5.0 Reactor Coolant System and ~~Connection~~ Connected Systems

5.1 Summary Description

The information in this section of the reference ABWR DCD, including all subsections and figures, as modified by the STP Nuclear Operating Company Application to Amend the Design Certification rule for the U.S. Advanced Boiling Water Reactor (ABWR), "ABWR STP Aircraft Impact Assessment (AIA) Amendment Revision 3," dated September 23, 2010 is incorporated by reference with the following departures.

Figure 5.1-1 Rated Operating Conditions of the ABWR

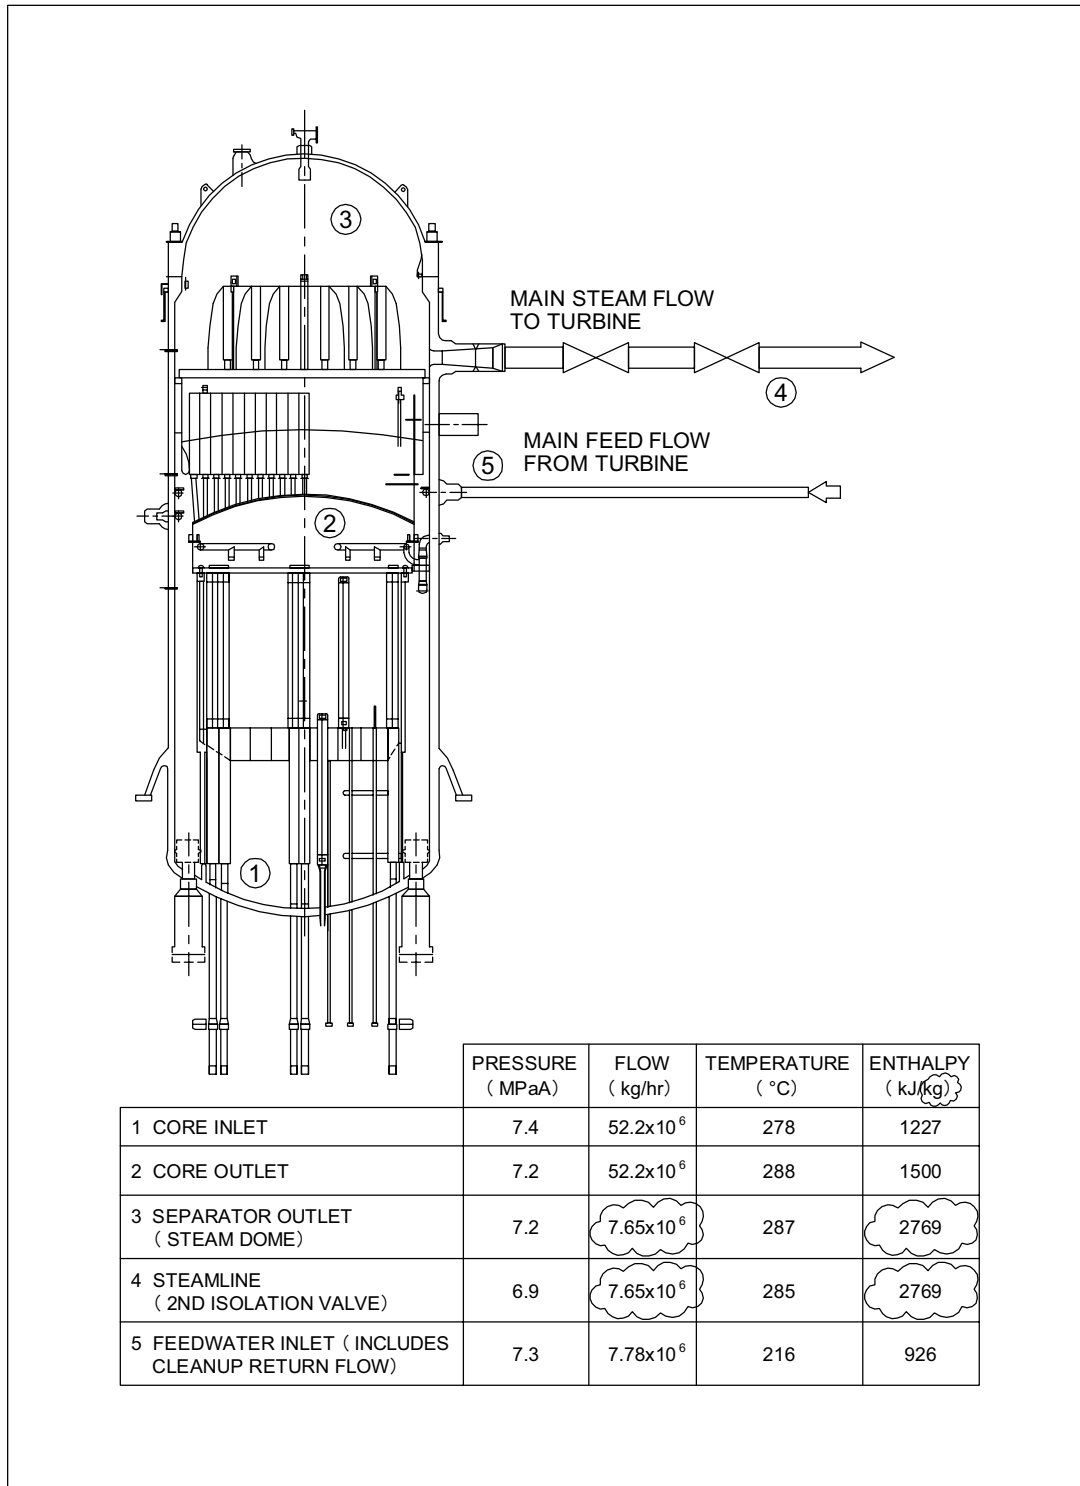
STP DEP 10.1-3 (Figure 5.1-1)
